Work Order ID 101700

Item Name: Crosstube Fwd High

DRAWING NO. D212-664-141	TITLE XTUBE ASSY (205/212/412 HI FWD)	REV. D	DART AEROSPACE LTD ENGINEERING ORDER		D.E.O. NO. D212-664-141-D-1	SHEET NO. SHEET 1 OF 2	SCALE NTS
DRAWN	CHECKED	MFG. APPR.	APPROVED	DE APPR.			
DATE 11.04.07	DATE 11.04.11	DATE 11.04.12	DATE 11/04/12	DATE 11.04.12

**D212-664-141/-141B
ASSEMBLY DETAIL**

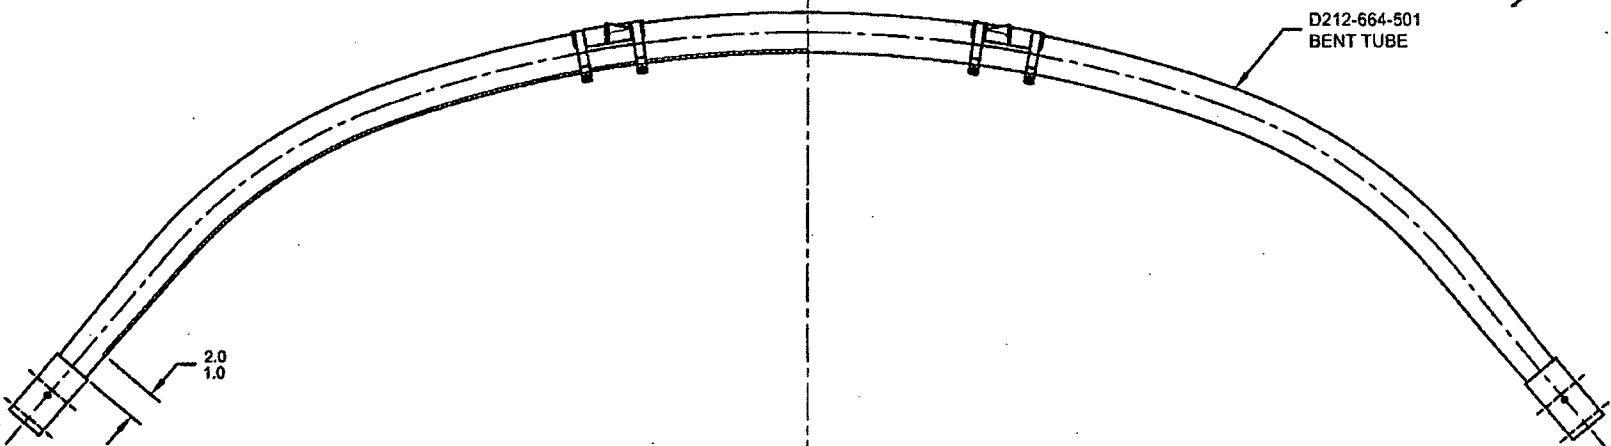
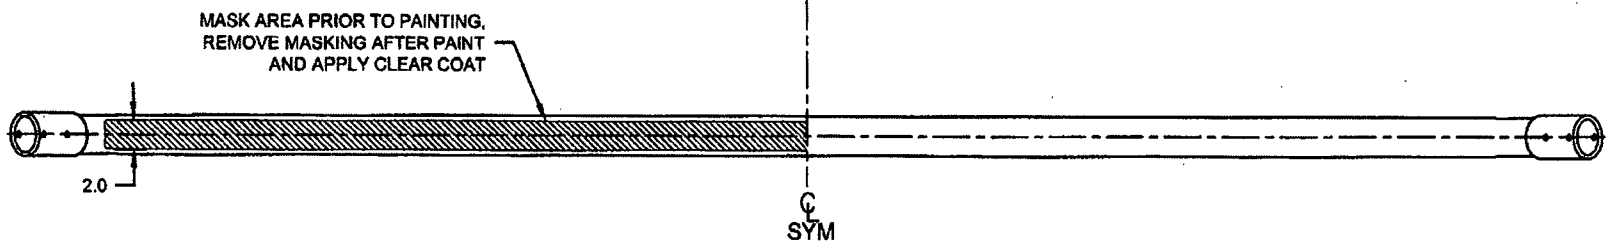
ADD AN INSPECTION WINDOW TO UNDERSIDE OF CROSSTUBE.

NOTES 2 OF SHEET 1 IS AMENDED AS FOLLOWS:

- 2) FINISH: CHEMICAL CONVERSION COAT PER DART QSI 005 4.1
PRIME INSIDE AND OUTSIDE PER DART QSI 005 4.2
MASK UNDERSIDE OF CROSSTUBE AS SHOWN (HATCHED AREA) AND
PAINT OUTSIDE PER DART QSI 005 4.2
REMOVE MASKING AND APPLY CLEAR COAT
